Office Action Summary

10/810,914

This is the first Office Action for application number 10/810,914 Camera Mount, filed on 3/26/04. Claims 1-12 are pending.

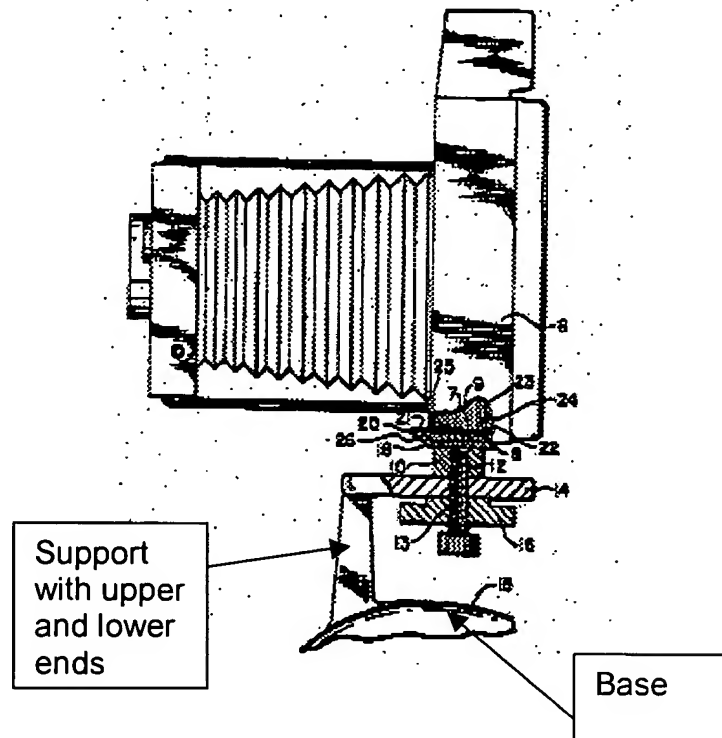
Henning discloses applicant's basic inventive concept including a camera mount having a planar surface (14) which could carry advertising or information, the camera mount having a base (15), and a substantially rigid column support (See Drawing Below) upstanding from the base (15) and having upper and lower ends, the lower end being attached to the base (15). Henning also shows that at the upper end of the support, a camera platform (8) is adjustable about a vertical axis and has a camera

mounting surface. Henning also shows that a rotatable standard camera mount screw (13) is projecting from the camera mounting surface.
